Work Order ID 61193

Item Name: Basket Hoop

DESIGN #	DRAWN BY CP	DART AEROSPACE LTD HAWKESBURY, ONTARIO, CANADA	
CHECKED #	APPROVED #	DRAWING NO. D3166	REV. A SHEET 1 OF 1
DATE 02.07.10		TITLE BASKET HOOP	SCALE NTS
A	02.07.10	NEW ISSUE	
A1	CP 04.04.08	38+-1 WAS 36.0

DRAWING NO. D3166	TITLE BASKET HOOP	REVA1	DART AEROSPACE LTD ENGINEERING ORDER		D.E.O. NO. D3166-A-2	SHEET NO. 1 OF 1	SCALE NTS
DRAWN AJS	CHECKED 1	MFG. APPR. M	APPROVED M		DE APPR. H		
DATE 08.12.11	DATE 08.12.15	DATE 08/12/15	DATE 08/12/16		DATE 08.12.16

D3166-1 BASKET HOOP

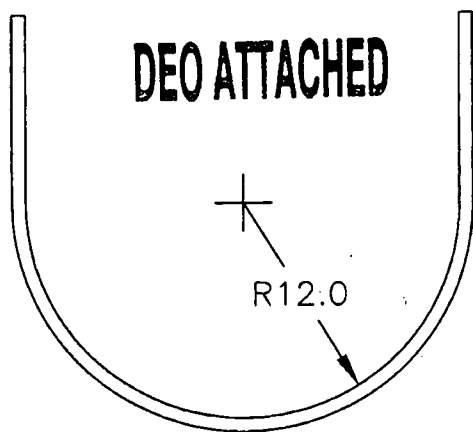
1) MODIFY MATERIAL NOTE FOR D3166-1 AS SHOWN:

WAS:

1) MATERIAL: AISI 304/316 SS SQUARE TUBING,
0.75" x 0.75" x 0.063 WALL, 60.00" LONG
(REF DART SPEC. M304TS0.750W.063)

IS:

1) MATERIAL: AISI 304/316 SS, 3/4 X 3/4 X 0.065 WALL SQUARE TUBING,
60.00" LONG
REF. DART SPEC M304TS0.750W.065

D3166-3 BASKET HOOP

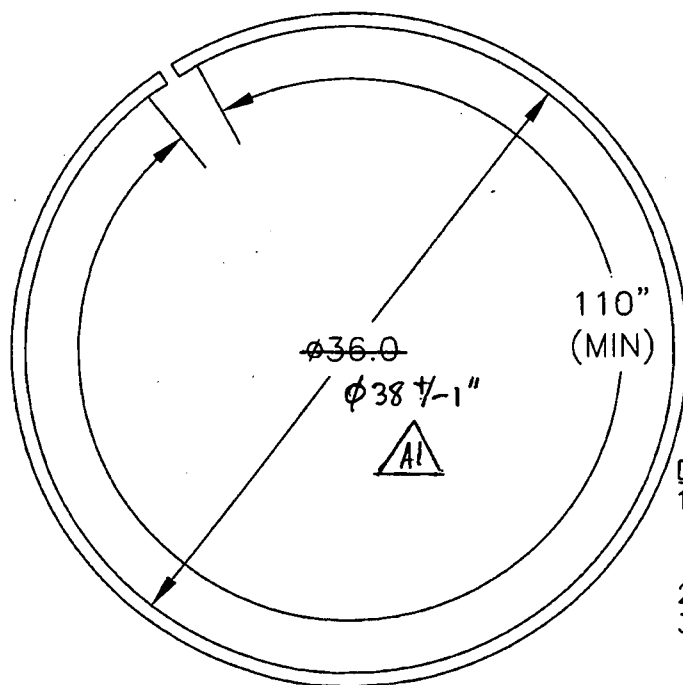
2) MODIFY MATERIAL NOTE FOR D3166-3 AS SHOWN:

WAS:

1) MATERIAL: AISI 304/316 SS SQUARE TUBING,
0.75" x 0.75" x 0.063 WALL, 120.00" LONG
(REF DART SPEC. M304TS0.750W.063)

IS:

1) MATERIAL: AISI 304/316 SS, 3/4 X 3/4 X 0.065 WALL SQUARE TUBING,
120.00" LONG
REF. DART SPEC M304TS0.750W.065
